**MINERALS PROGRAM INSPECTION REPORT**  
**PHONE: (303) 866-3567**

<b>MINE NAME:</b> Indio Red Quarry Number 1 & 2	<b>MINE/PROSPECTING ID#:</b> M-1999-062	<b>MINERAL:</b> Sandstone (silica, st quartzite)	<b>COUNTY:</b> Larimer
<b>INSPECTION TYPE:</b> Monitoring	<b>INSPECTOR(S):</b> Robert Zuber, P.E.	<b>INSP. DATE:</b> September 22, 2020	<b>INSP. TIME:</b> 11:45
<b>OPERATOR:</b> Hector Rodriguez	<b>OPERATOR REPRESENTATIVE:</b> Raul Vasquez	<b>TYPE OF OPERATION:</b> 110c - Construction Limited Impact

**Figure 1. Boundary of Indio Red Quarries Number 1 and 2 per Markers on the Ground**

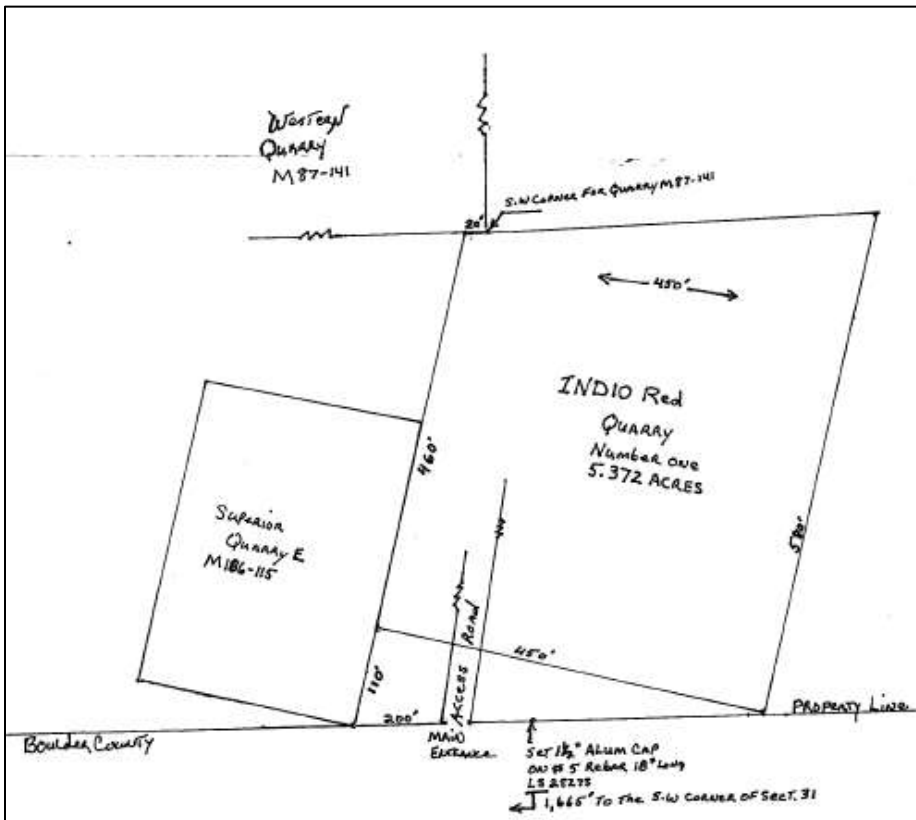
**PROBLEM/POSSIBLE VIOLATION:** Problem: The affected area boundary markers are incorrectly placed. This is a problem for failure to maintain boundary markers around the affected area as required by Section 3.1.12(2) of the rule.

Permit boundary markers were found at the corners of the two areas that make up the site, and these were checked using GPS and by comparing to the boundary outline in the site plan from the permit application. There appears to be one or more issues with the marking of the boundary. The shapes of the areas based on the on-the-ground markers are different than the shapes in the site plan. Also, the dimensions may be off. For example at Quarry Number 2, the south side is about 350 feet long per Google Earth, but the site plan indicates that it should be 445 feet.

**CORRECTIVE ACTIONS:** The operator shall conduct a survey and replace the boundary markers in the correct location(s). The operator shall provide proof to the Division that this has been done by the corrective action date.
